Addendum #3

Project Name: Nebraska History Museum Renovation
131 Centennial Mall N.
Lincoln, NE 68508

Project No.: 13059-05

M403b

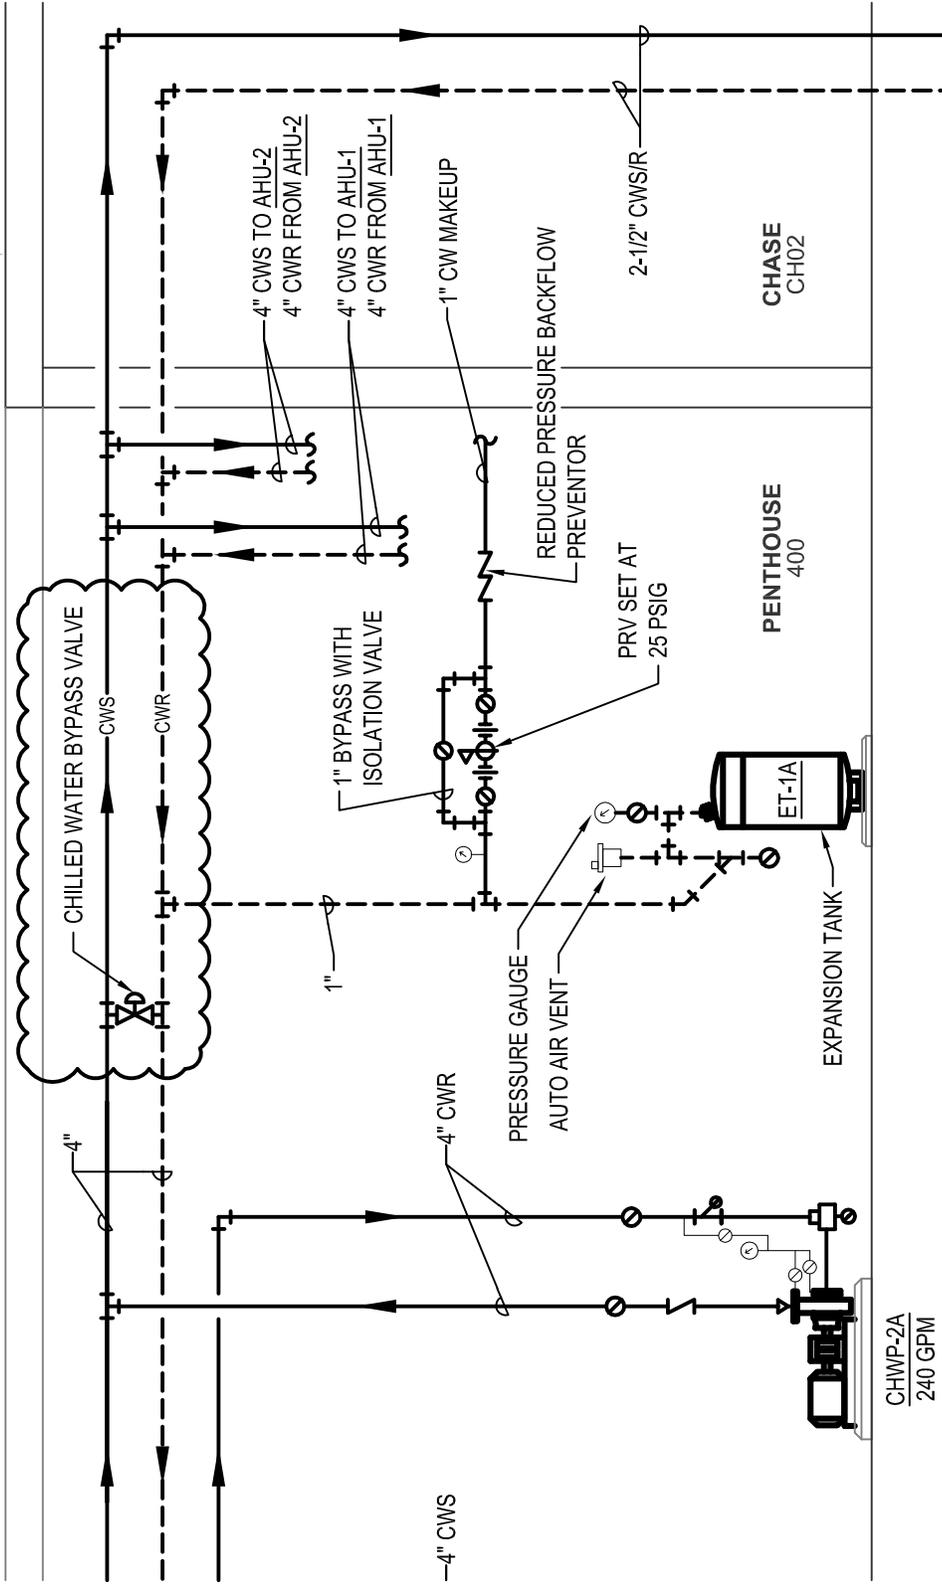
1. See attached **Sketch M403a** for Cooling Coil Detail piping modifications from 3-way control valve to pressure-independent control valve.
2. See attached **Sketch M403b** for Alt. 03 Chilled Water Piping Schematic to show chilled water bypass valve and piping.

E201a

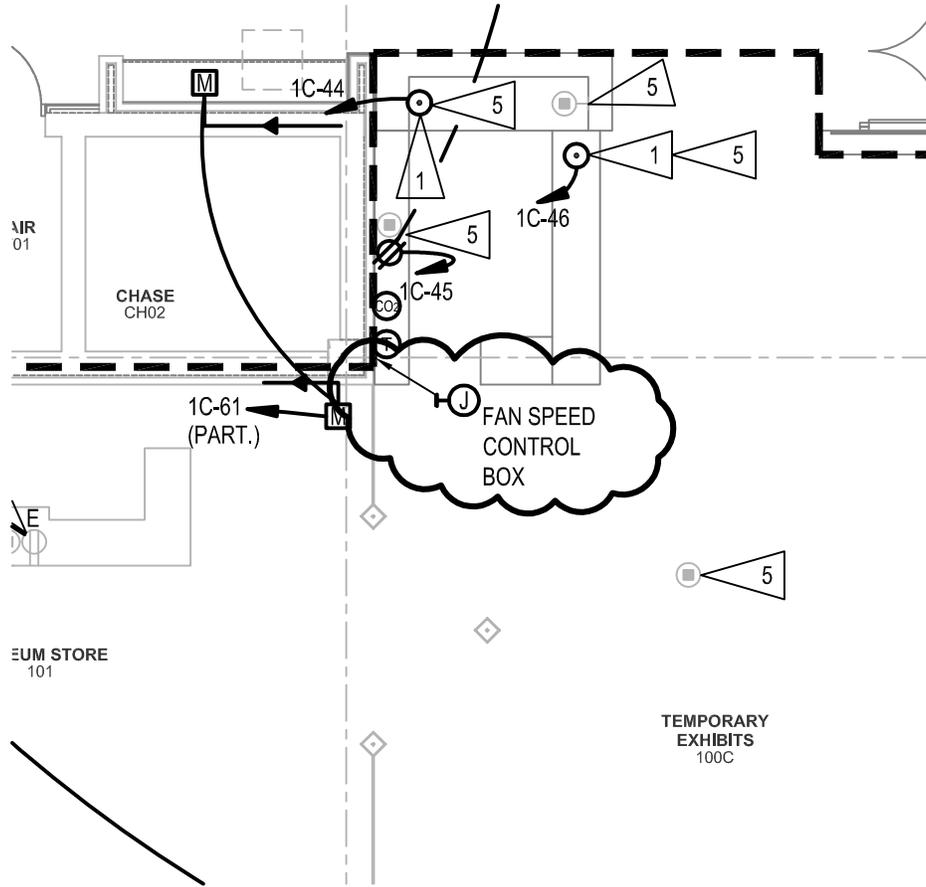
1. See attached **Sketch E201a** for location of fan speed control box.
